ST. TAMMANY PARISH

Addendum No.: 1

Bid#: 24-43-2

Project Name: Brewster Road Sewer Consolidation

SHEET NO.
40E-04

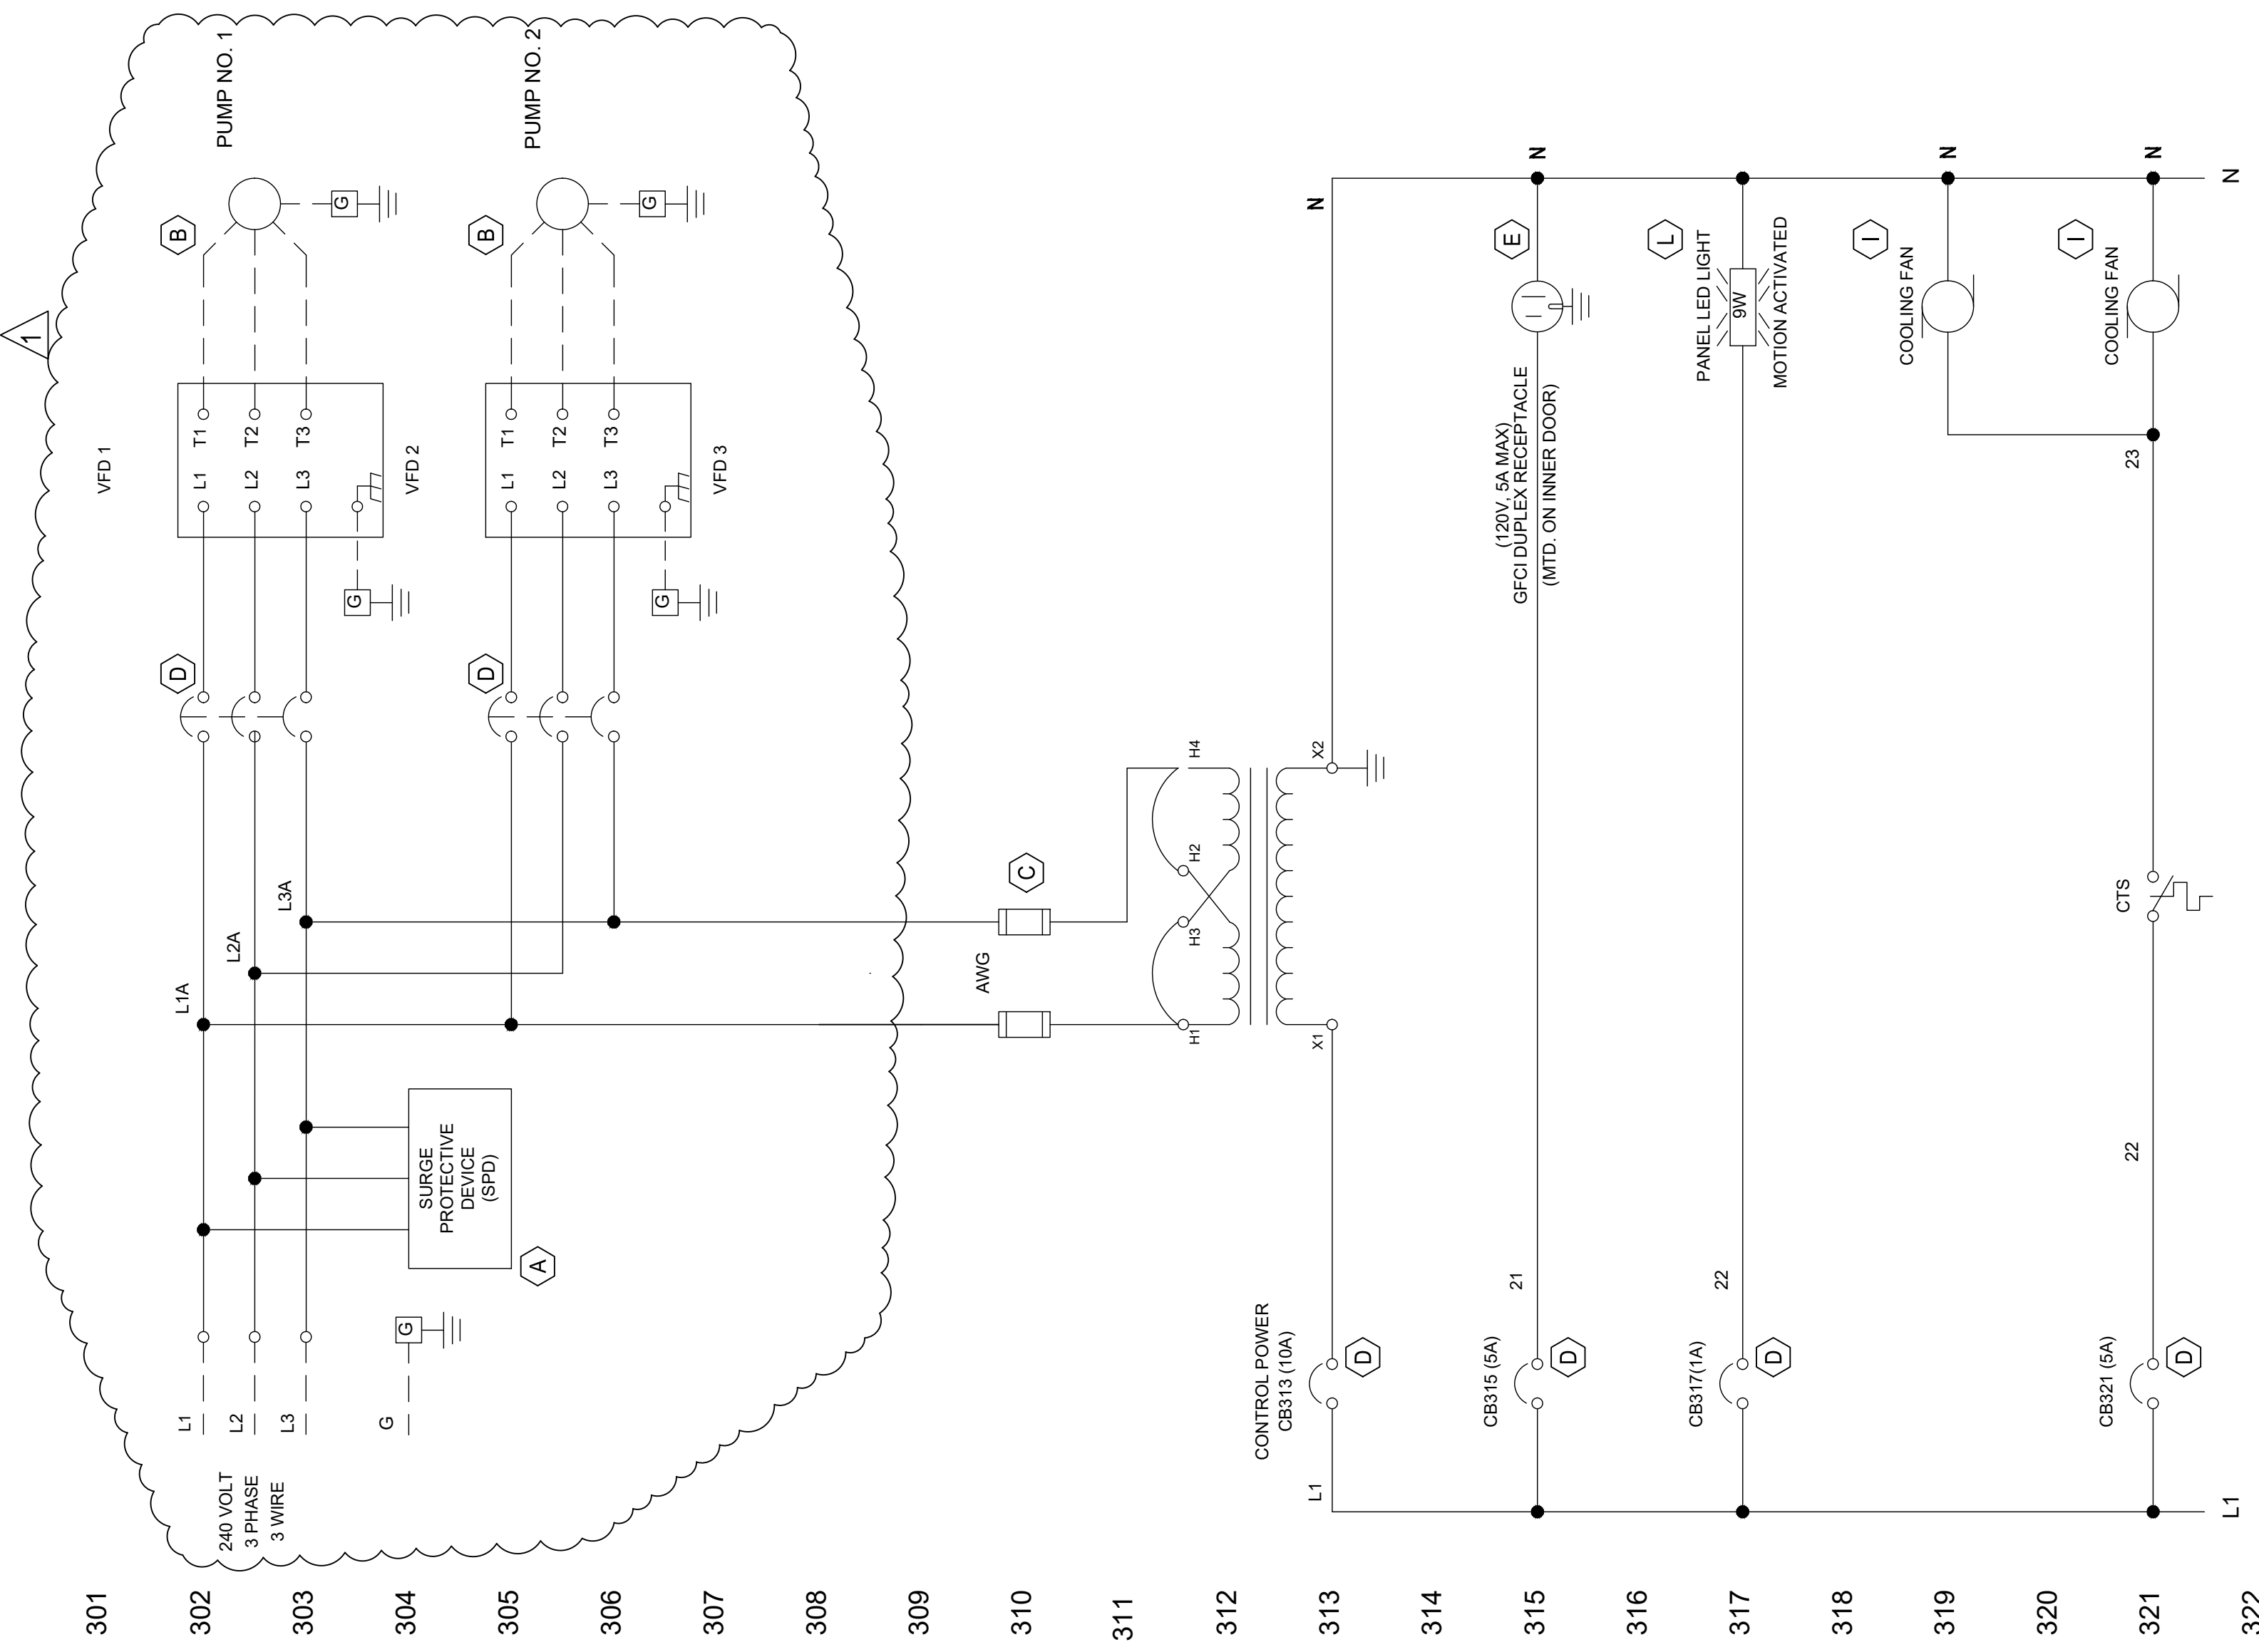
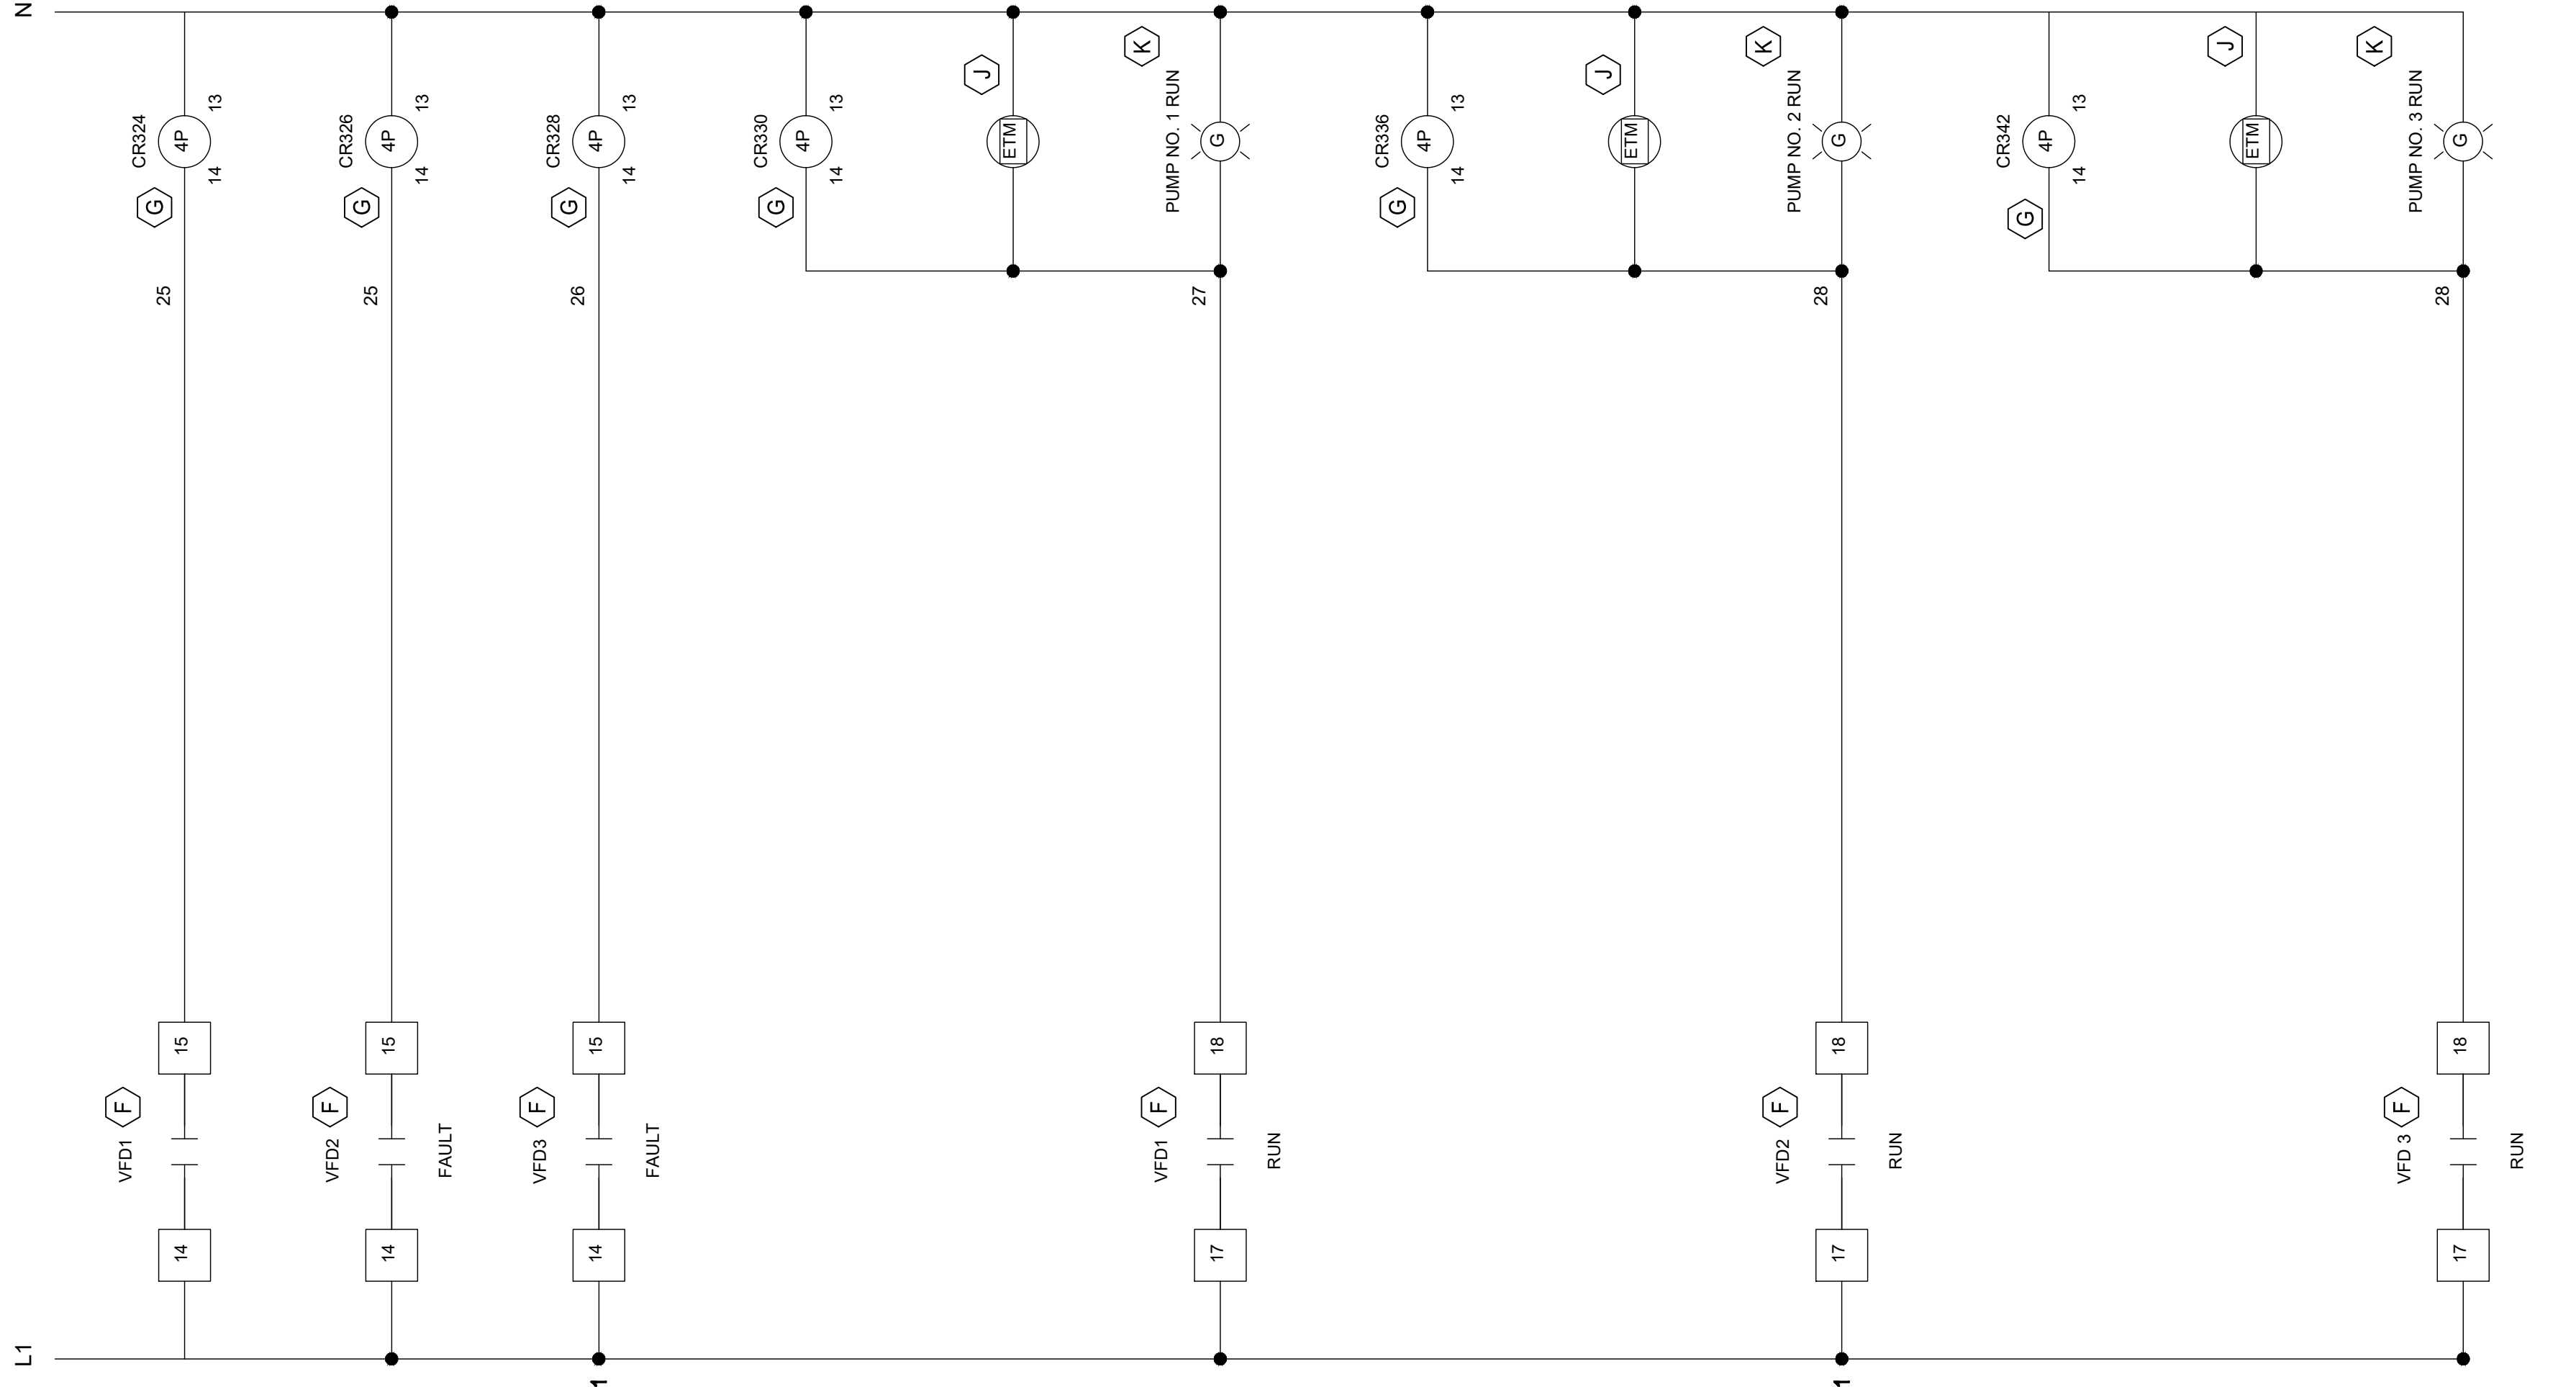
- e. DELETE Drawing 20PP-02 and REPLACE with the attached REVISED Drawing 20PP-02.
- f. DELETE Drawing 20PP-03 and REPLACE with the attached REVISED Drawing 20PP-03.
- g. DELETE Drawing 20PP-04 and REPLACE with the attached REVISED Drawing 20PP-04.
- h. DELETE Drawing 20PP-05 and REPLACE with the attached REVISED Drawing 20PP-05.
- i. DELETE Drawing 30-03 and REPLACE with the attached REVISED Drawing 30PP-03.
- j. DELETE Drawing 40PP-02 and REPLACE with the attached REVISED Drawing 40PP-02.
- k. DELETE Drawing 40PP-03 and REPLACE with the attached REVISED Drawing 40PP-03.
- l. DELETE Drawing 40E-02 and REPLACE with the attached REVISED Drawing 40E-02.
- m. DELETE Drawing 40E-04 and REPLACE with the attached REVISED Drawing 40E-04.
